MAS004102 RU 24-12

RAPID UPDATE

Rapid Update 712

GranTurismo – Air Springs Replacement

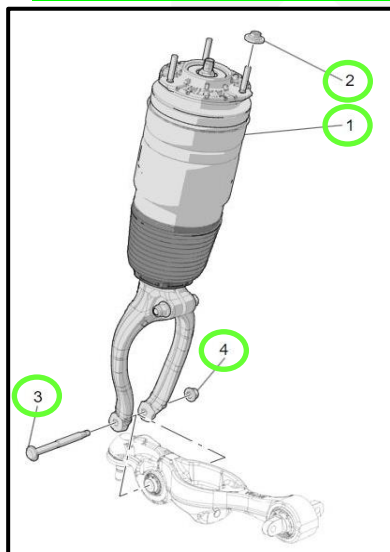
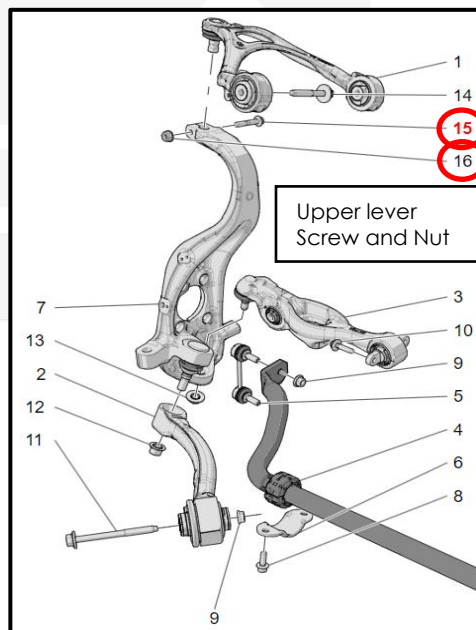
FOR THIS ACTION ONLY: Although the workshop manual states to replace the "Upper lever screw," it is not necessary for this action. See the Spare Parts Table on page 4 of this bulletin for components to be replaced.

Components to be replaced

Components NOT to be replaced

SPARE PARTS TABLE (M189)	Pos	PN	QTY
RH FRONT SHOCK ABSORBER	1	670311033	1
LH FRONT SHOCK ABSORBER	1	670311029	1
Shock absorber upper nuts	2	675001506	6
Shock absorber retaining screw	3	670159150	2
Shock absorber nut	4	675001189	2

SPARE PARTS TABLE (M189) BEV	Pos	PN	QTY
RH FRONT SHOCK ABSORBER BEV	1	670311030	1
LH FRONT SHOCK ABSORBER BEV	1	670311034	1
Shock absorber upper nuts	2	675001506	6
Shock absorber retaining screw	3	670159150	2
Shock absorber nut	4	675001189	2
